**Council
Assessment Report**

2015SYW142 (DA/849/2015)

Hornsby PYC

JRPP No	2015SYW142
DA Number	DA/849/2015 (Lodged 9 July 2015)
Local Government Area	Hornsby
Proposed Development	Hornsby PCYC – Demolition of existing tennis court complex and construction of a new indoor recreation facility with basement car parking.
Street Address	Lots 300 and 301 DP 832745 Nos. 20X Waitara Avenue, Waitara (Waitara Oval) and 1 Park Lane, Waitara (Waitara Park -Tennis Courts)
Applicant/Owner	Facility Design Group Pty Ltd PO Box 82 CAMBEWARRA NSW 2540
Number of Submissions	Four (4) submissions
Regional Development Criteria (Schedule 4A of the Act)	The DA is referred to the JRPP pursuant to Schedule 4A of the <i>Environmental Planning and Assessment Act 1979</i> , as amended. The Panel is authorised to exercise the consent authority functions of Council as the development proposed has a combined capital investment value of more than \$5 million and the reserve is owned by Council and Council is a party to the development. Capital Investment value of the development - \$ 15,000,000

1 BASEMENT CAR PARK
1 : 200

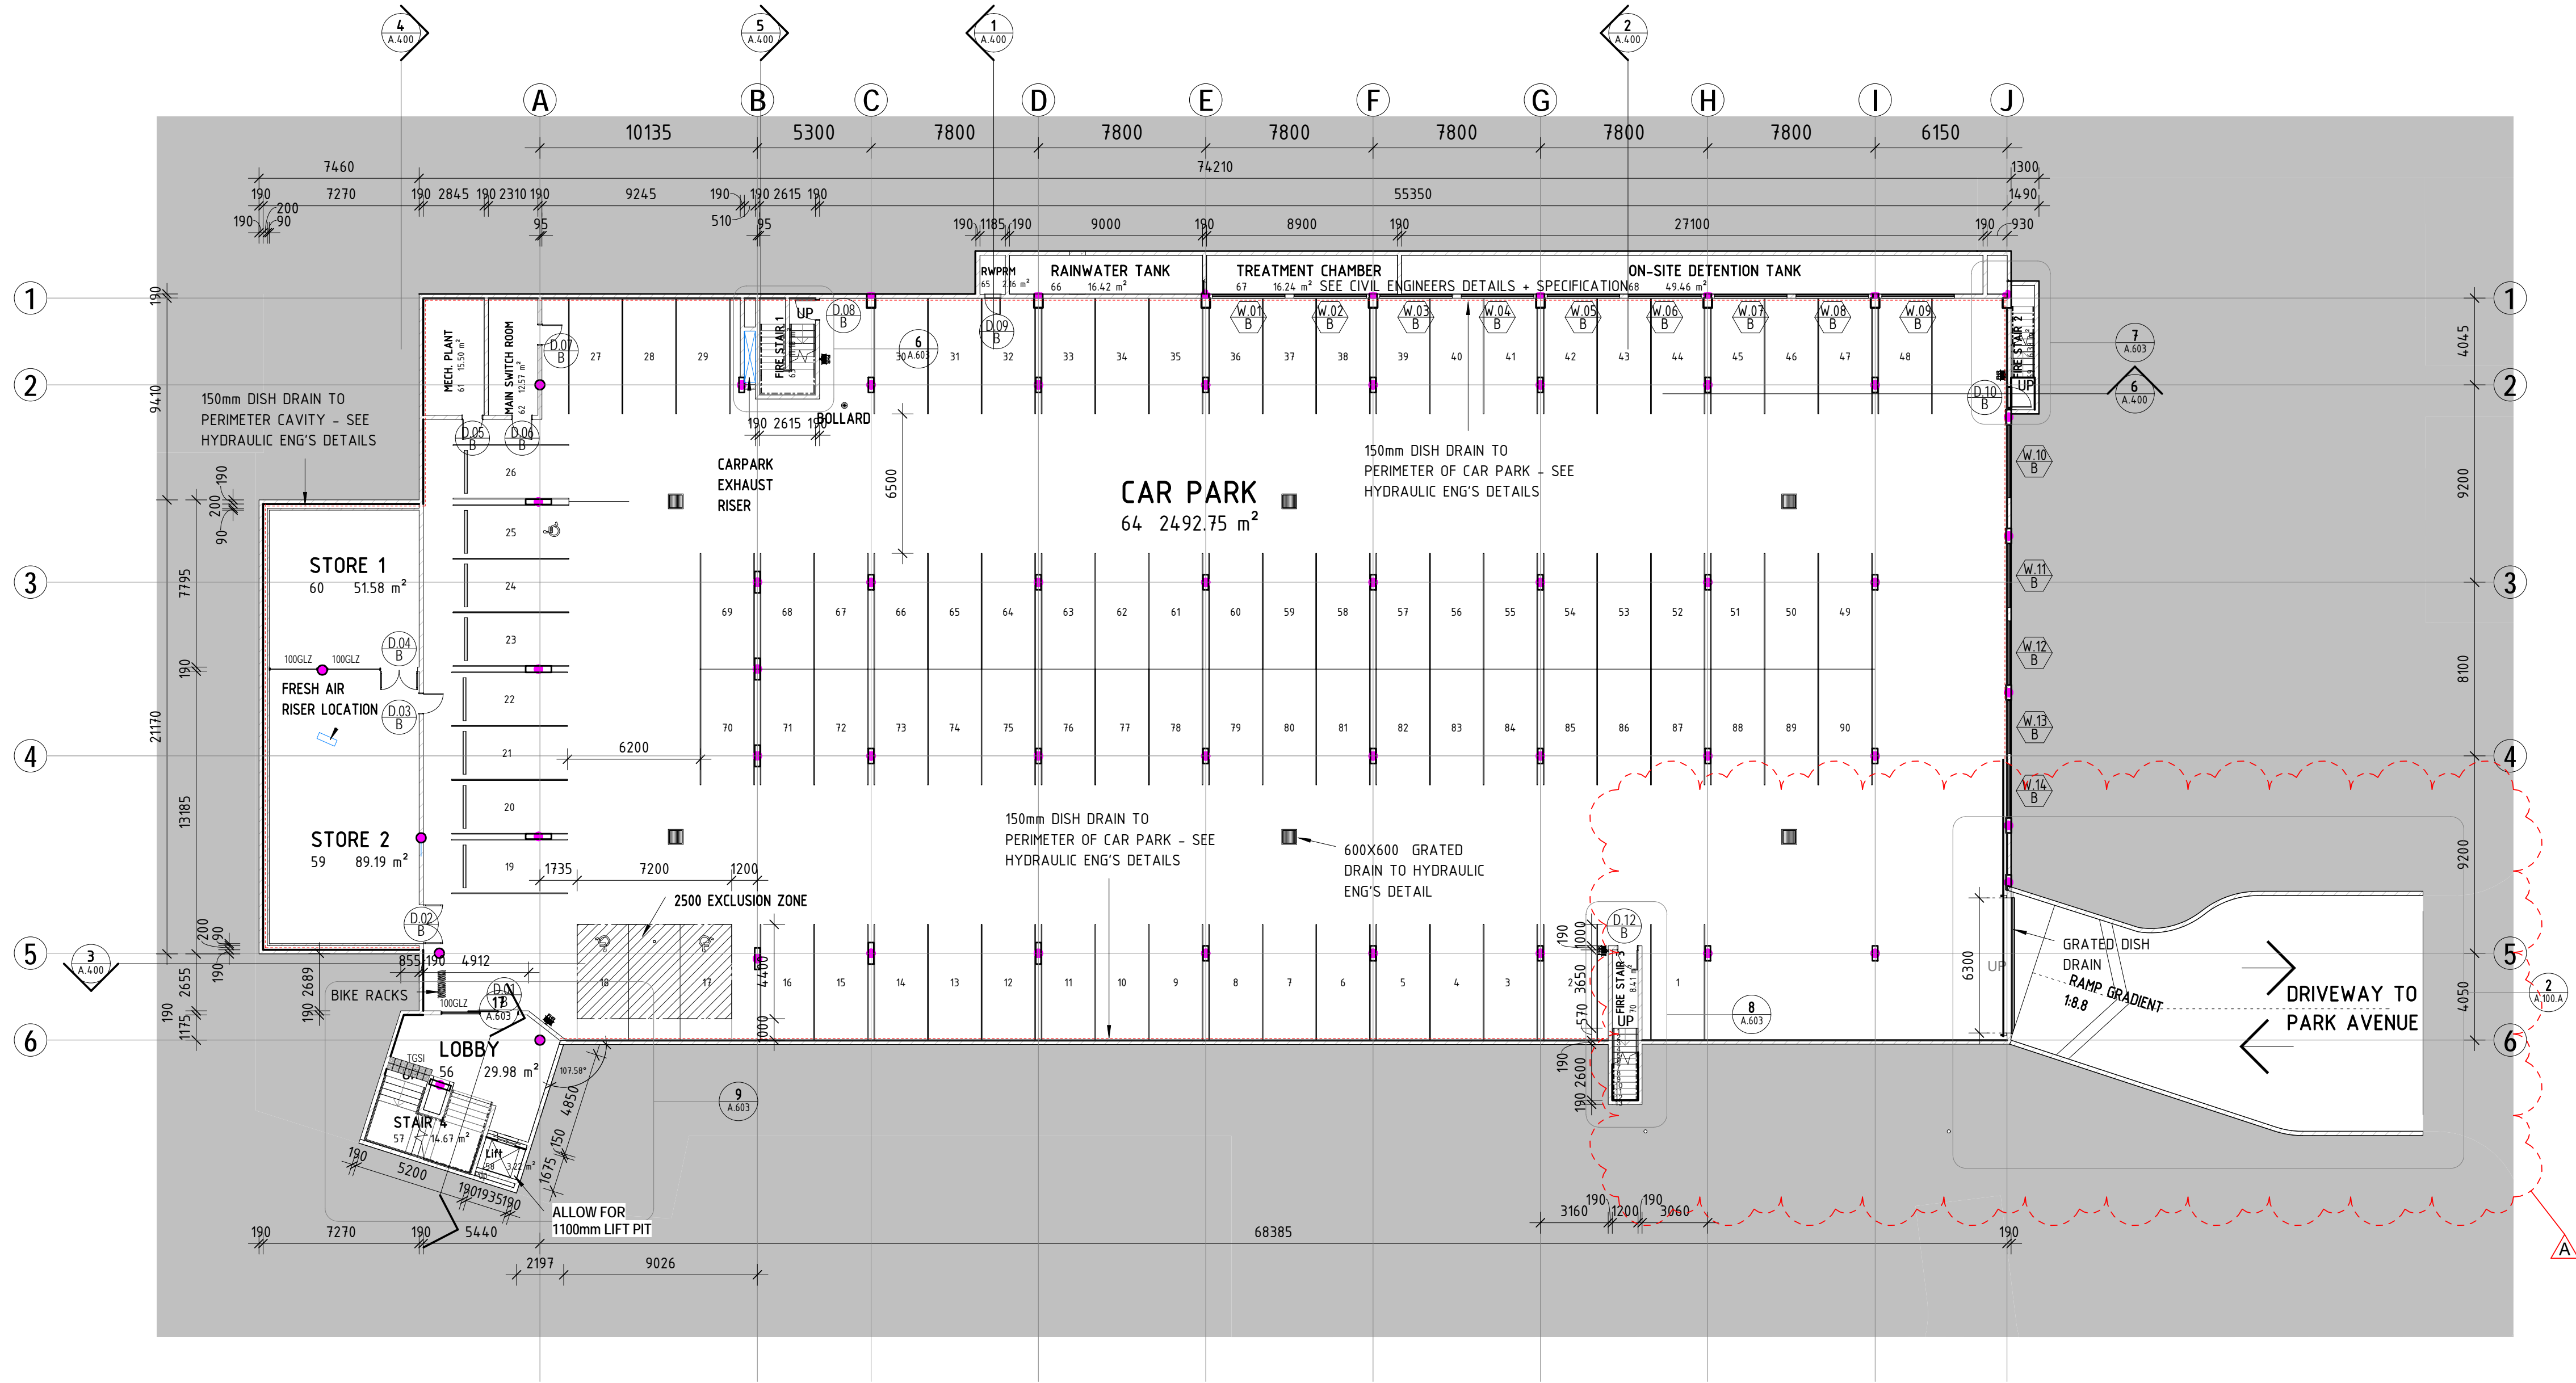
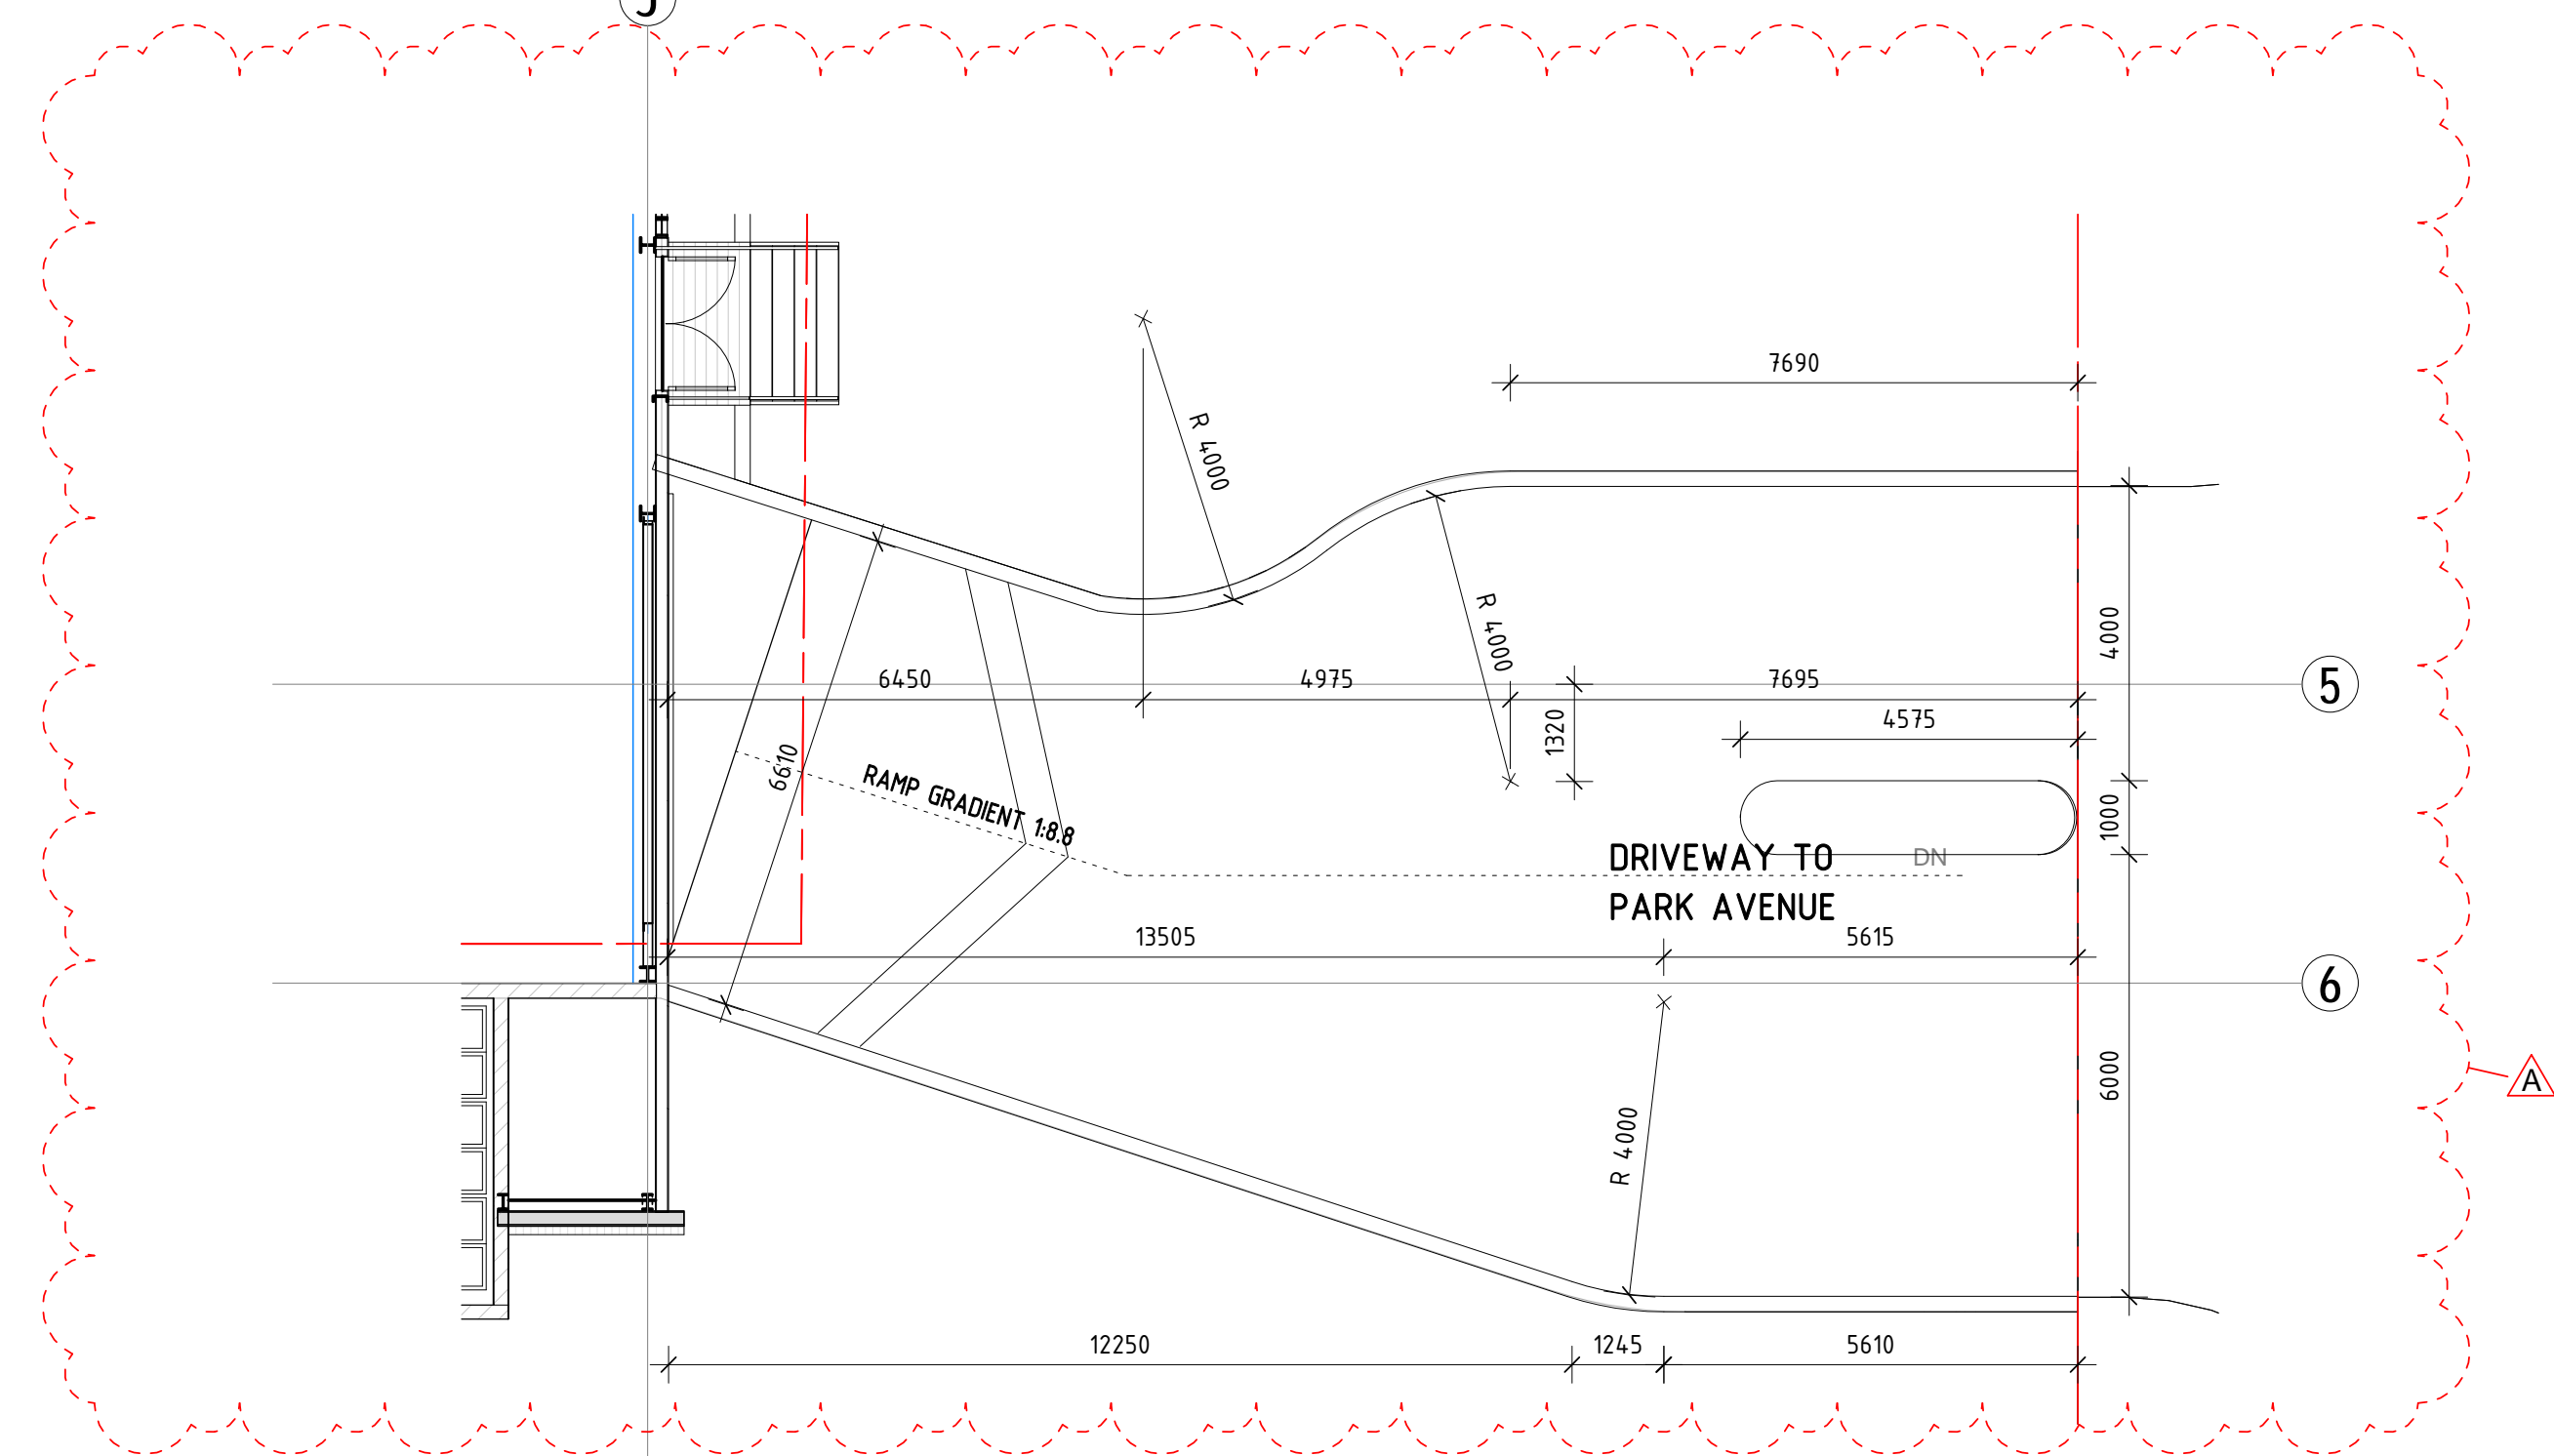
The Proponents have submitted revised plans in response to a number of the concerns raised by the Traffic and Road Safety Branch. In particular, the vehicle accessway to the basement car park has been redesigned to provide a separated entry and exit to comply with the design requirements under AS2890.1 class1.

Shadow Diagrams

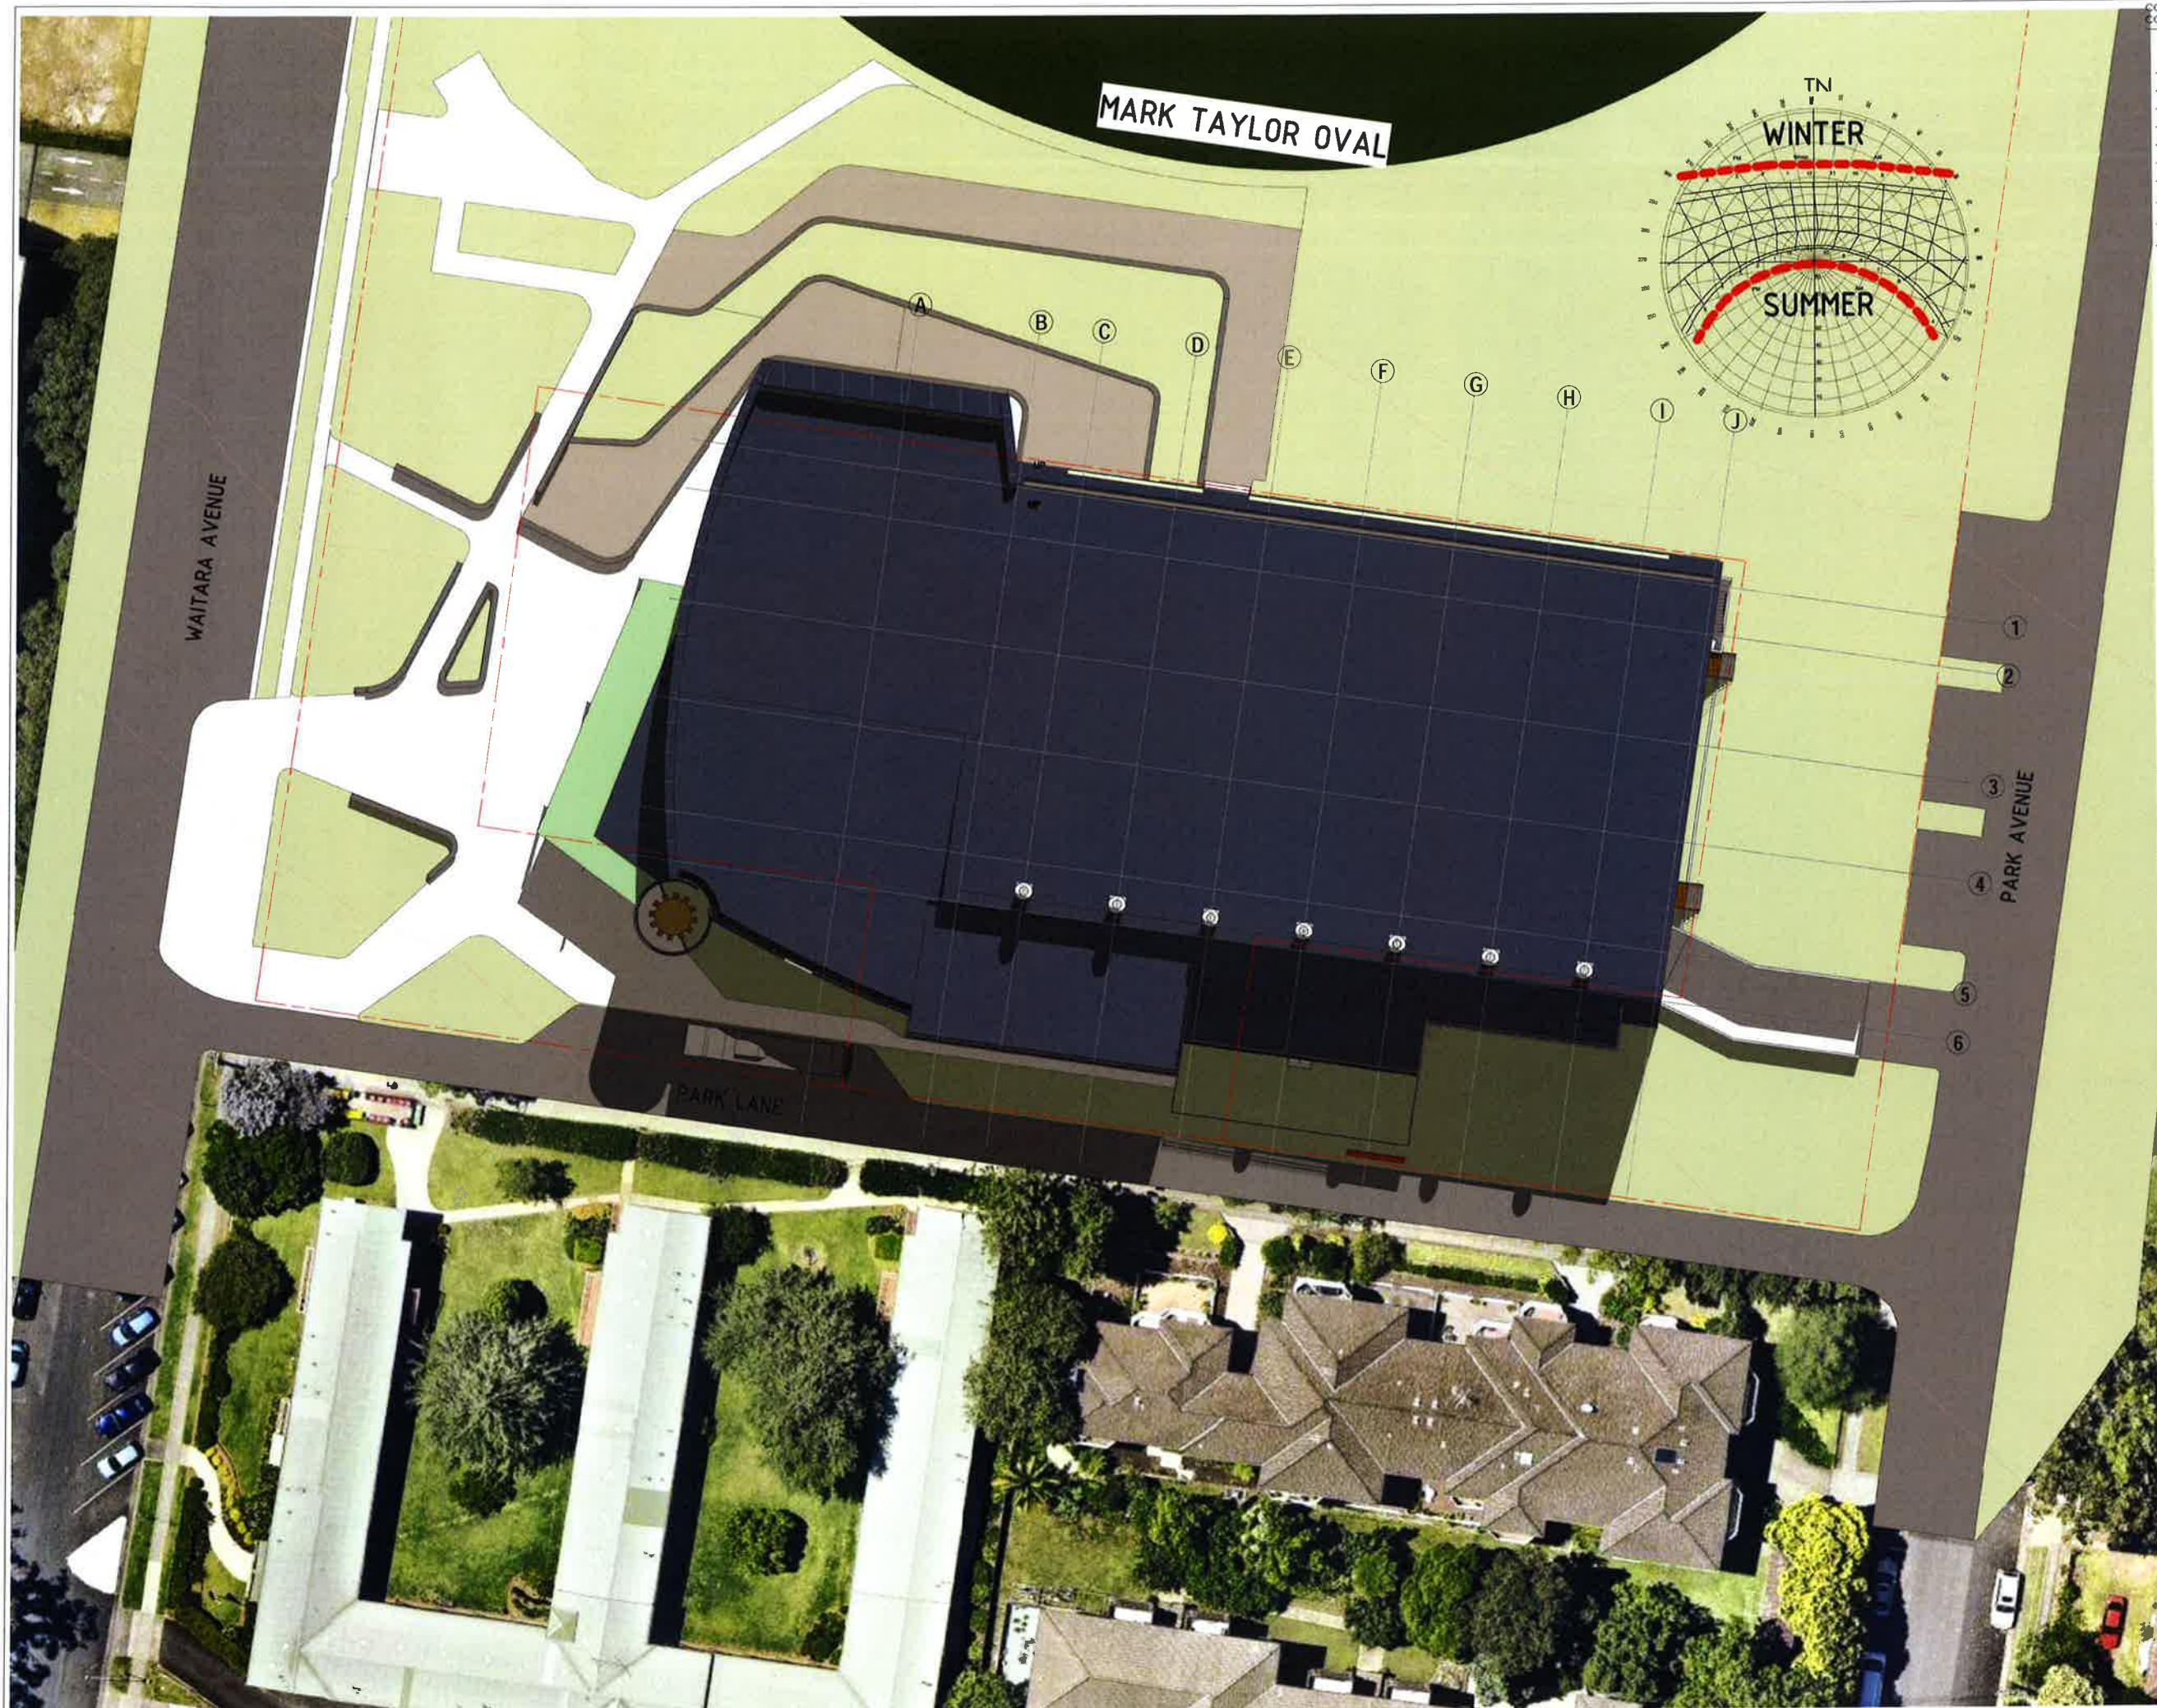
A concern has been raised by a resident opposite the site in Park Lane in relation to the accuracy of the shadow diagrams prepared as part of the development application. The objector is critical of the shadow diagram prepared for 9.00 am on 22 June and in particular that the diagram 'blanks out' the footprint of the affected buildings. This is considered to be a fair criticism of the plan.
